「MCMI-Ø16, Ø20, Ø25 Single Acting Type」 Length Change Notification

MCMI-13/15-Ø16, Ø20, Ø25 (Single Acting Type)

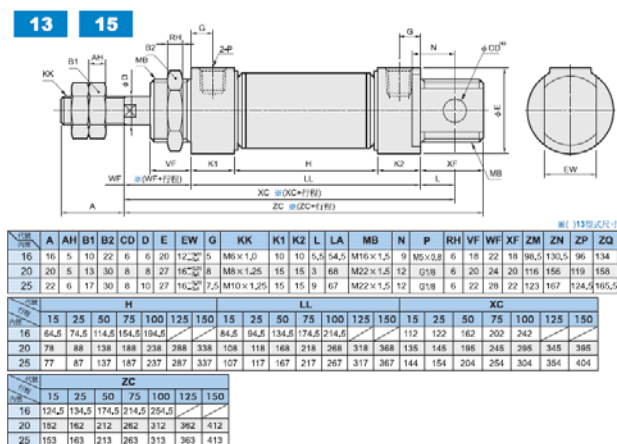
2. Design change reason

Shorten the total length to decrease the installing space requirement.

Dimensions

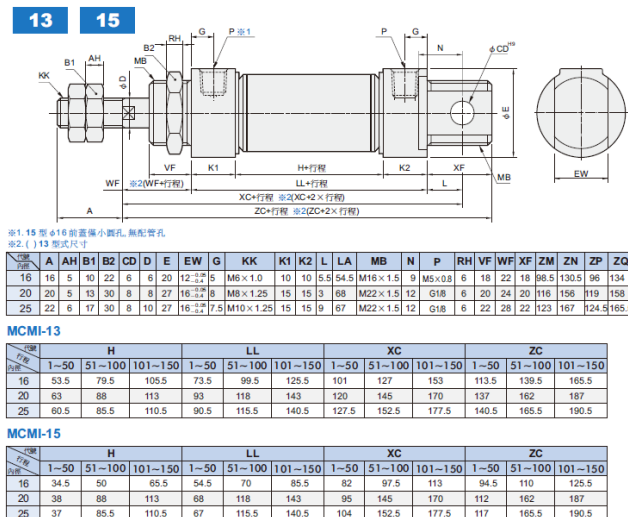
3. Design change details

Please check the table below or check our catalogs.

Before Dec. 31th 2016

After Jan. 1th 2017
